REQUEST FOR PROPOSAL - ADDENDUM 1
BIDDERS' CONFERENCE REPORT

Applicant	Coleman Indep School District 35
BEN	139853
Form 470 #	270001489
Description	COLE 2027-C2
Addendum #	1
Date Posted	10/30/2026
e-Bidding Link	https://kellogglc.bonfirehub.com/portal

Elem Server

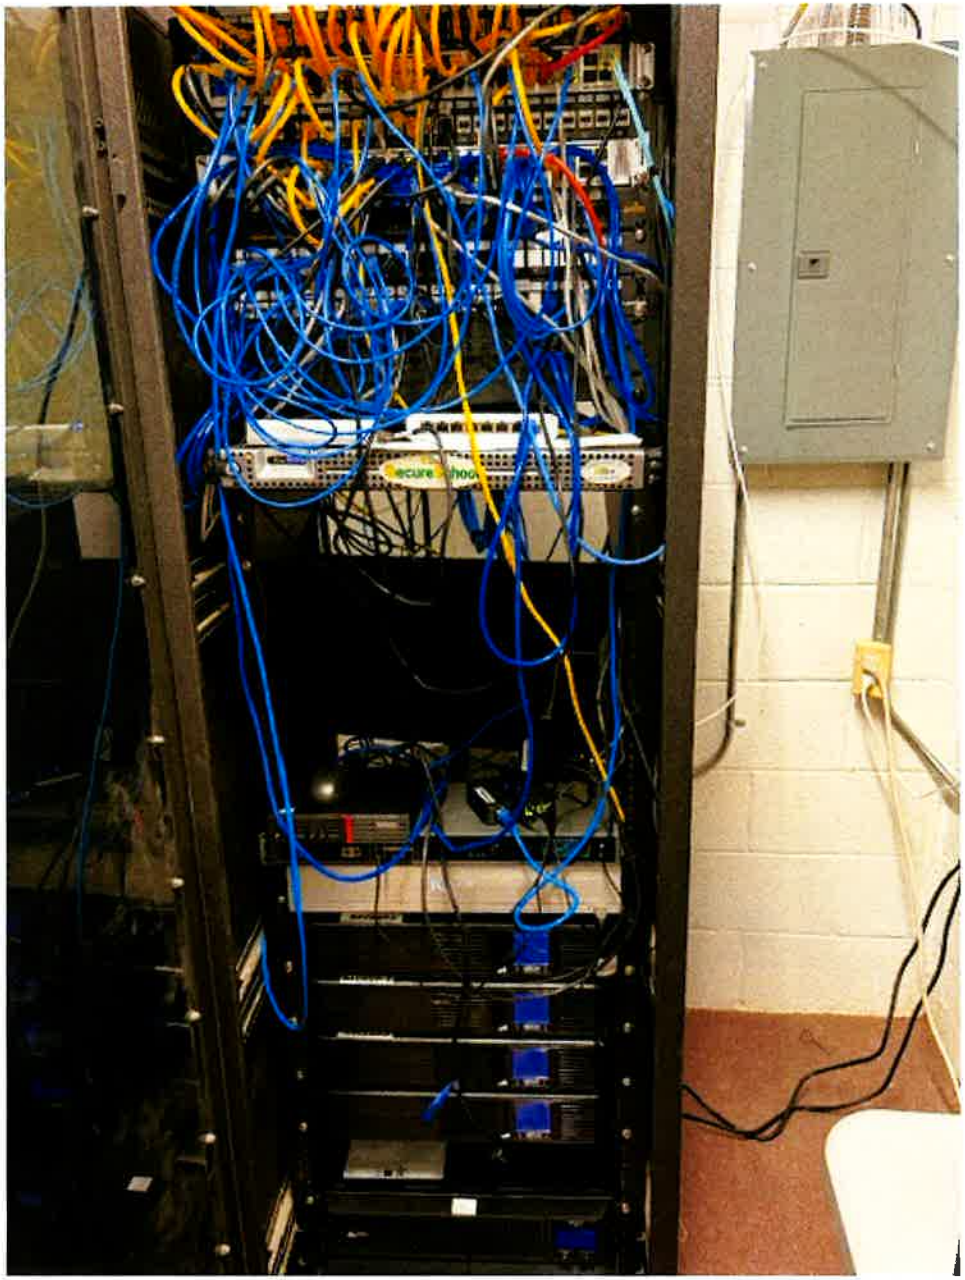
7. Question: Cabling and Cabinets **Are new cable runs expected, and is there a preferred cable type?**	**Answer:** **No new cabling is needed.**
8. Question: Cabling and Cabinets Where are the existing equipment cabinets, racks, or closets (MDF/IDF) located, and how much space and power are available for the switches and UPS units?	Answer: Please refer to the attached pictures showing the equipment racks and building locations.

4 - switches 48 port

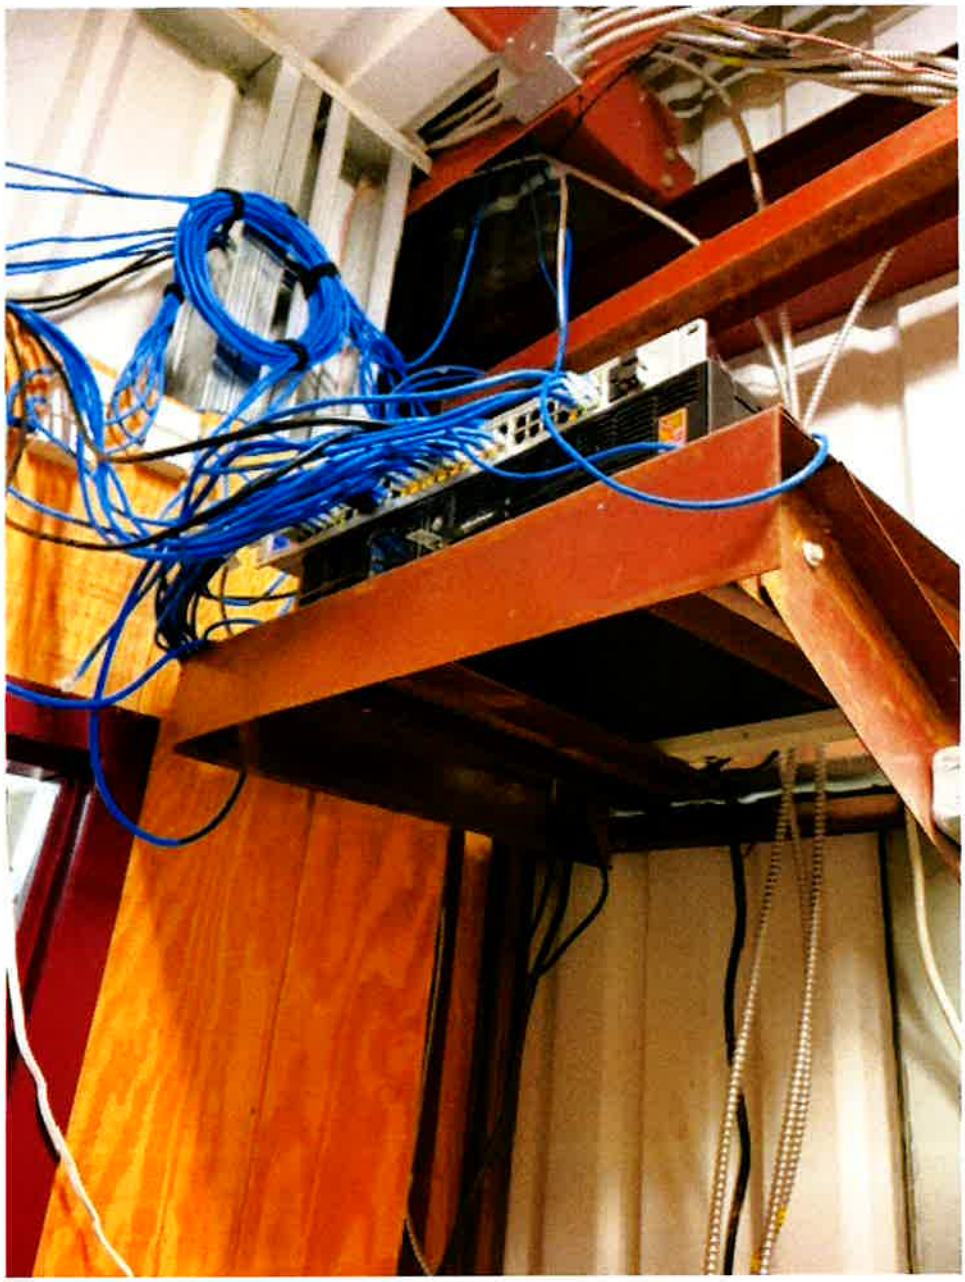
Questions & Answer Log	
9. Question: Cabling and Cabinets **Should the UPS units be rack-mounted or standalone? Is APC or Tripp Lite preferred?**	**Answer:** **Both APC and Tripp Lite are acceptable. The UPS units should be rack-mounted, except for one standalone unit for the agricultural building.**

- Ag Building
- 1 Switch 24 port
- 1 Backup

- Gym
- 1 Switch 24 Port
- 1 Backup -
